REVISION 2

NICOR GAS - CONSTRUCTION

BARE STEEL MAIN REPLACEMENT-BS189

WESTERN AVENUE TO QUINCY STREET

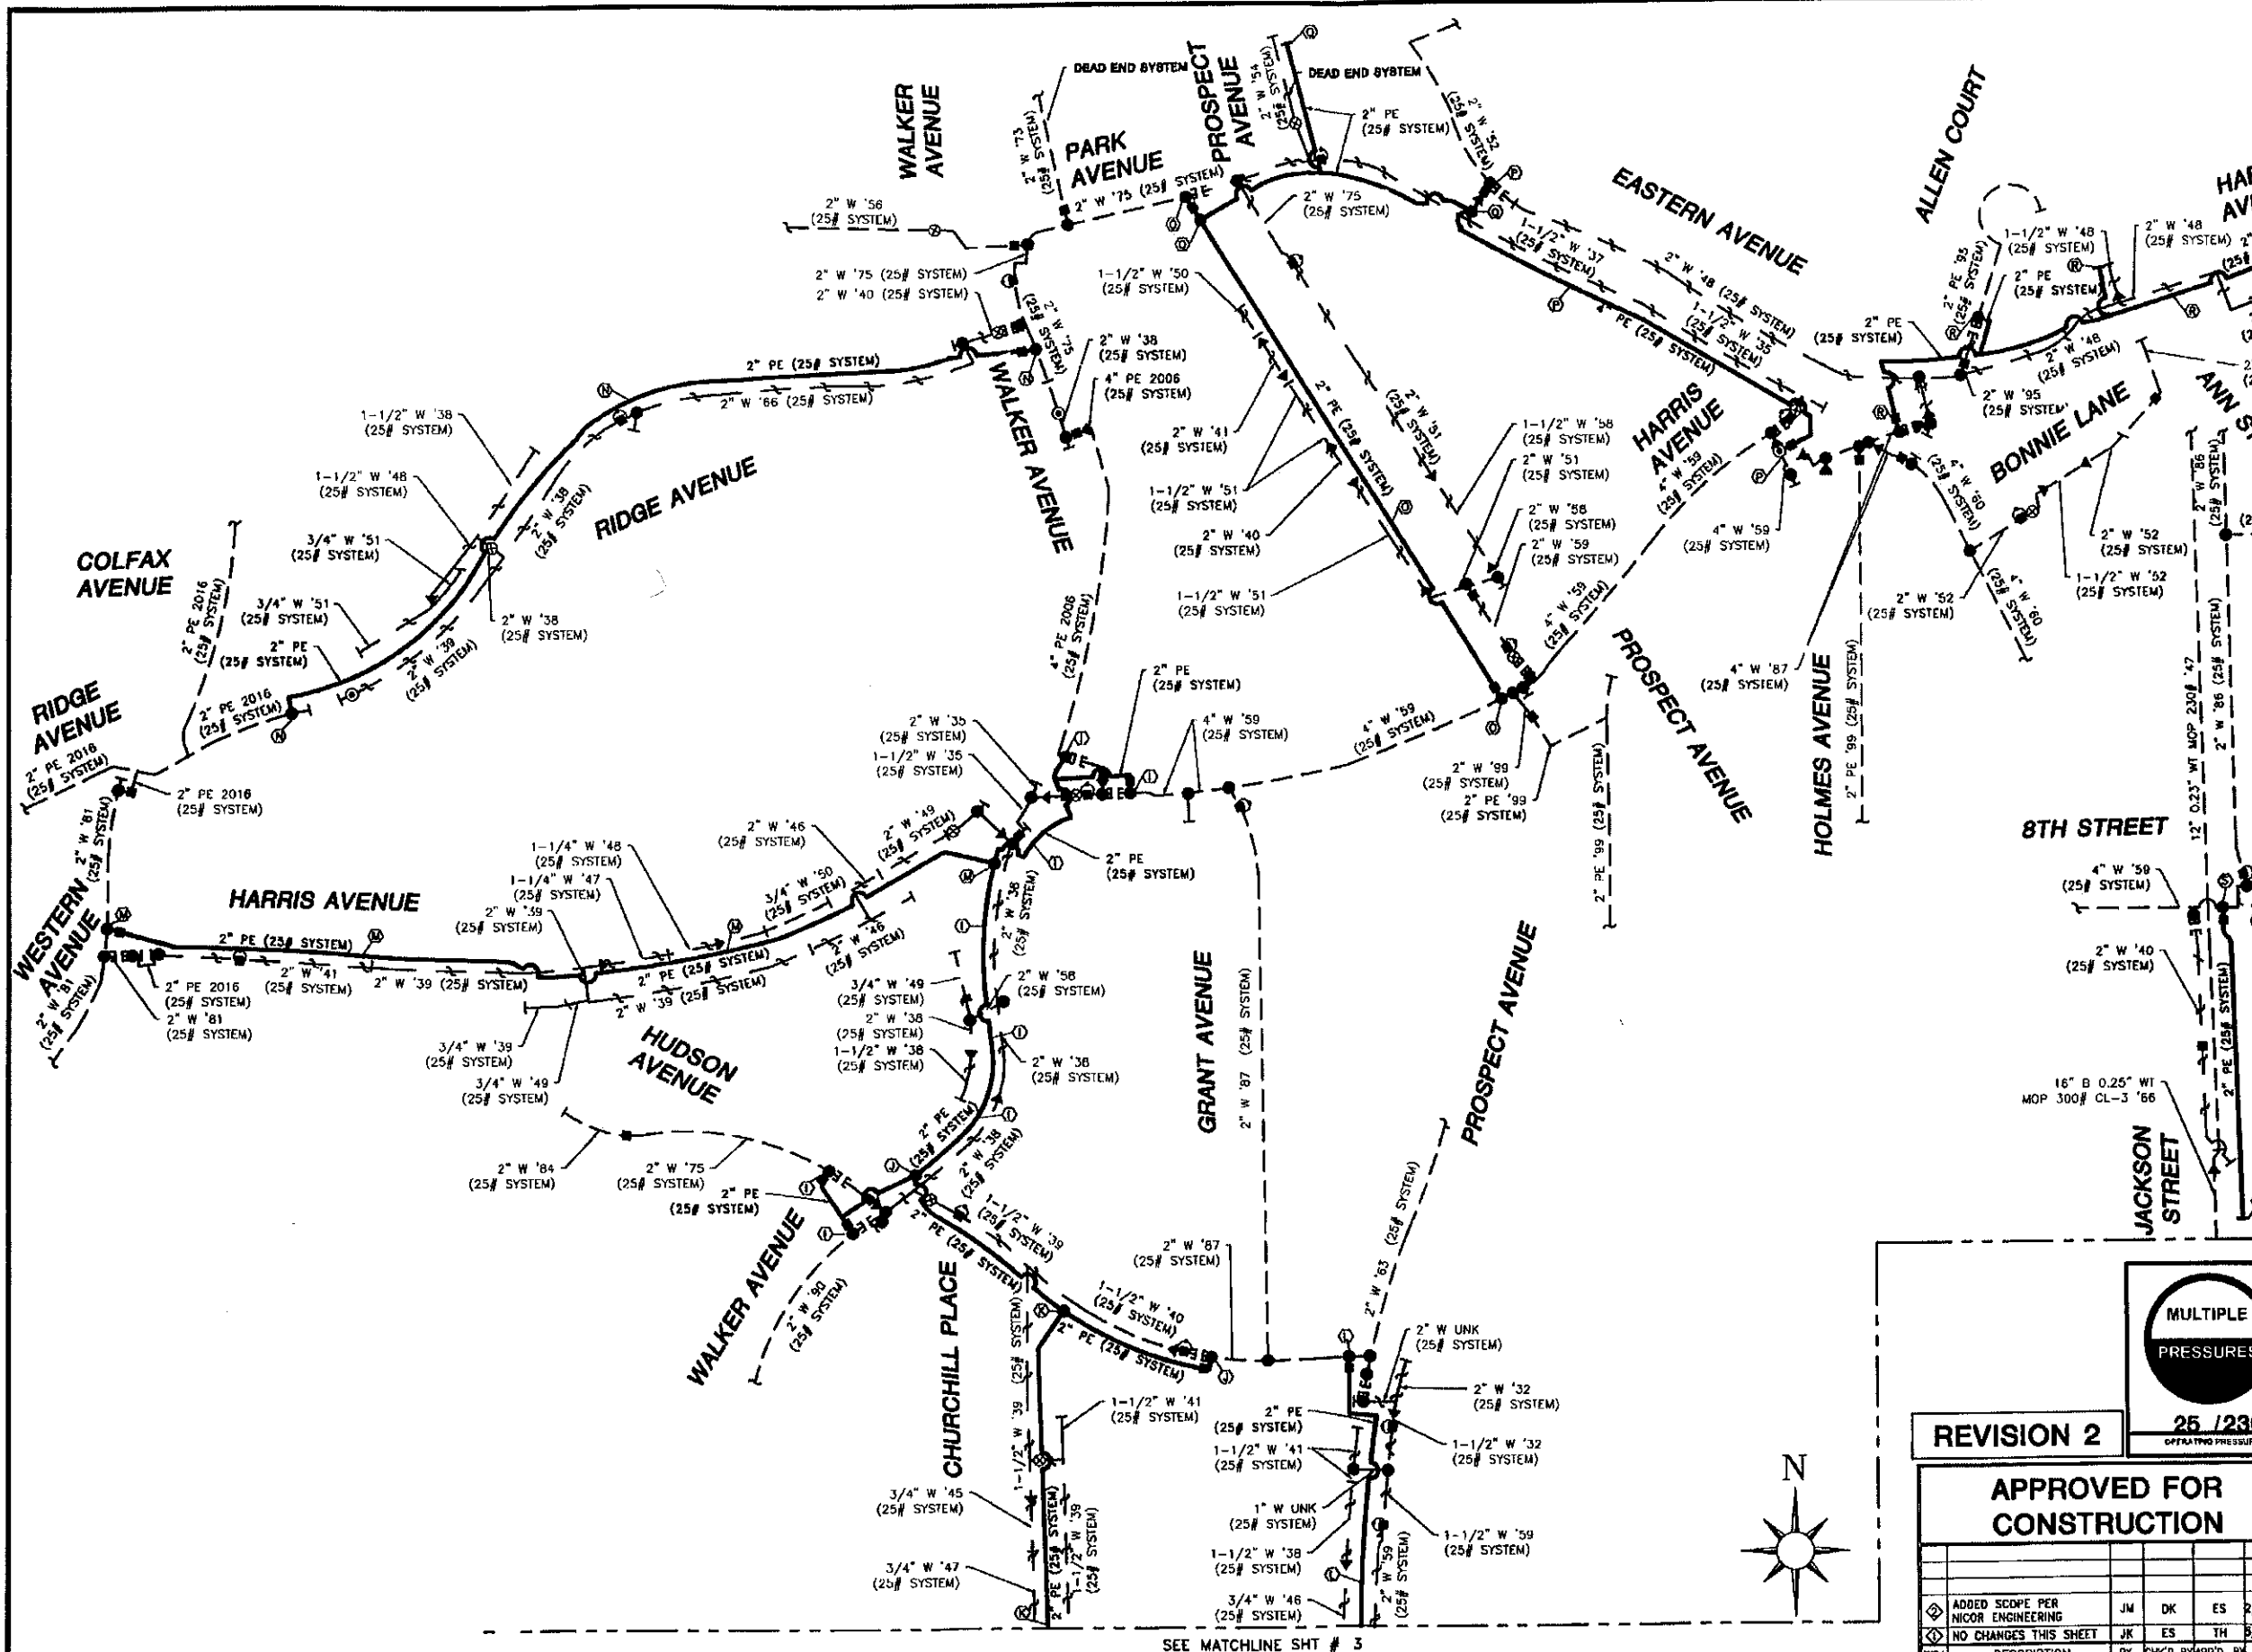
APPROVED FOR CONSTRUCTION	
ADDED PROPOSED WATER UTILITIES AND EXTEND MAIN PER ENGINEERING REQUEST	JM DK ES 2/
UPDATED EXISTING WATER MAIN AND ADDED CONSTRUCTION NOTES PER WESTMONT AND CLARENDON HILLS PERMIT COMMENTS.	JK ES TH 8/
REV. DESCRIPTION	BY CHK'D BY APP'D. BY

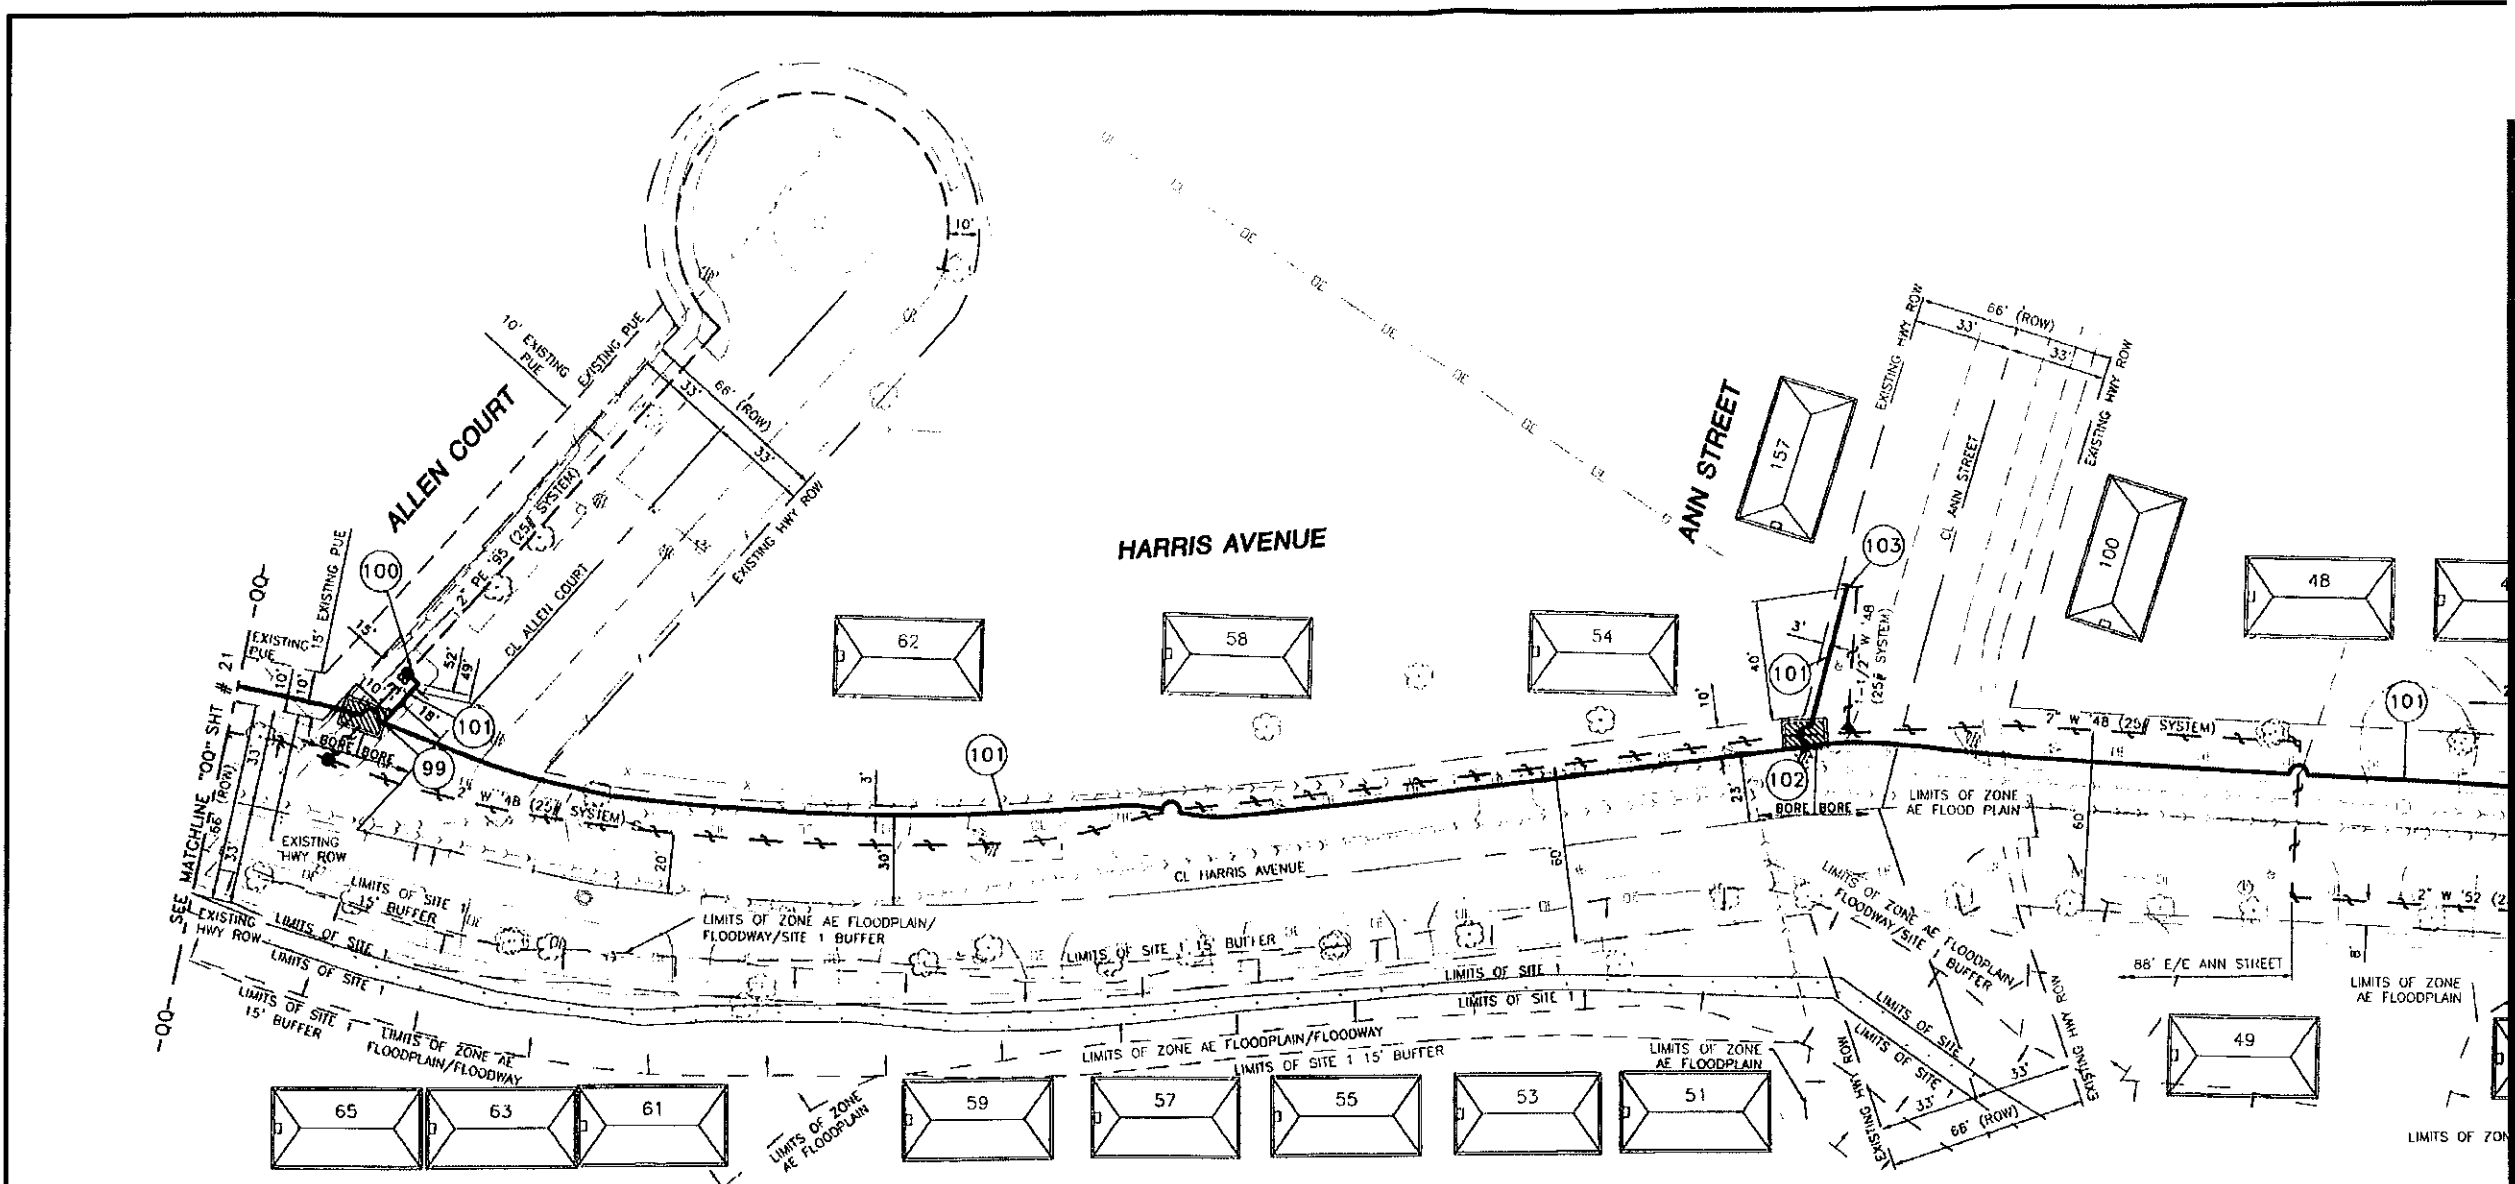
<input checked="" type="checkbox"/>	NO CHANGES THIS SHEET	JM	DK	ES	2/
<input checked="" type="checkbox"/>	ADDED CONSTRUCTION NOTE PER VILLAGE OF CLARENDON HILLS PERMIT COMMENTS.	JK	ES	TH	3/
REV.	DESCRIPTION	BY	CHK'D	APP'D	BY

- INSTALL PIPELINE MARKERS PER GCS 249. SEE SPECIFICATION FOR ALL REQUIREMENTS. FOR CLASS 1 & 2 LOCATIONS, MARKERS ARE REQUIRED OVER EACH BURIED MAIN AT EACH CROSSING OF A PUBLIC ROAD. IN ADDITION, PIPELINE MARKERS ARE REQUIRED AT ALL RAILROAD AND WATERWAY CROSSINGS.
- LOCATION AND SIZE OF STOCKPILES AND SILT FENCE AROUND STOCKPILES ARE APPROXIMATE. CONTRACTOR TO DETERMINE EXACT LOCATION AND SIZE AT THE TIME OF CONSTRUCTION.
- A MINIMUM 4' OF HORIZONTAL SEPARATION IS TO BE MAINTAINED FROM VILLAGE OF CLARENDON HILLS WATER MAIN.
